THE HIGHWAY TRAFFIC ACT
(C.C.S.M. c. H60)

Traffic Control Devices Order, amendment

Regulation 106/2014
Registered April 10, 2014

Sunday/Holiday Bicycle Route Street Closure sign (MR-178 and MR-178F)

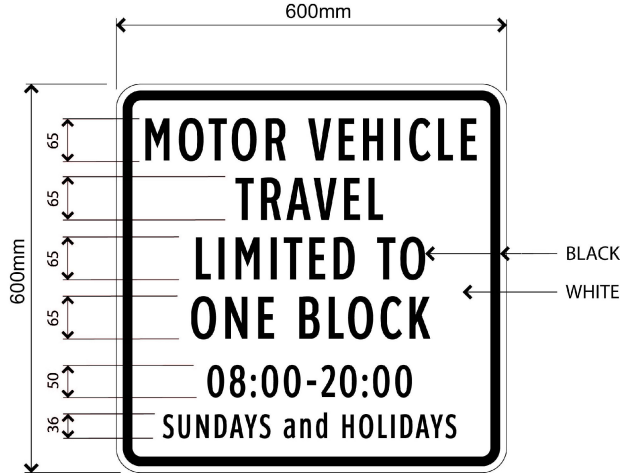
65.26(1) A “Sunday/Holiday Bicycle Route Street Closure” sign MR-178 or MR-178F may be used to indicate to drivers

- (a) that motor vehicle travel is limited to one block on a designated Sunday/Holiday Bicycle Route; and
- (b) the hours of the day and days of the week when the motor vehicle travel is limited.

MR-178

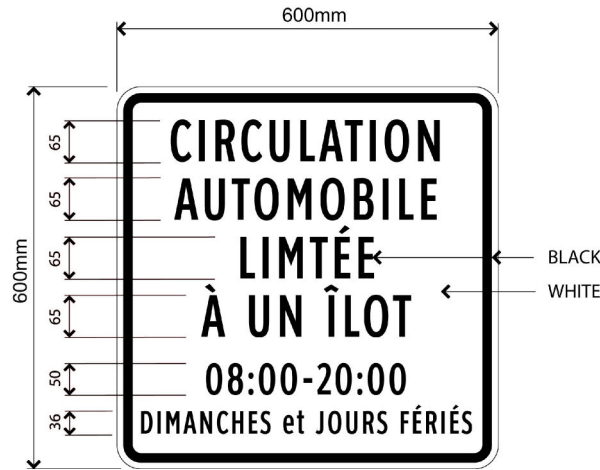
65.26(2) A “Sunday/Holiday Bicycle Route Street Closure” sign MR-178 must

- (a) be square in shape;
- (b) be not less than 600 mm in width and 600 mm in height;
- (c) be white in colour and
 - (i) in the upper portion, display the words “Motor Vehicle Travel Limited To One Block” in black upper case letters not less than 65 mm in height,
 - (ii) in the bottom portion, display
 - (A) the time of day in black numerals not less than 50 mm in height, and
 - (B) the words “Sundays and Holidays” in black upper case and lowercase letters not less than 36 mm in height;
- (d) be available in a French version as shown in the illustration labelled “MR-178F”;

- (e) be reflectorized to show the same colour and shape by night as by day; and
- (f) bear the markings and have the dimensions illustrated in either of the following illustrations:
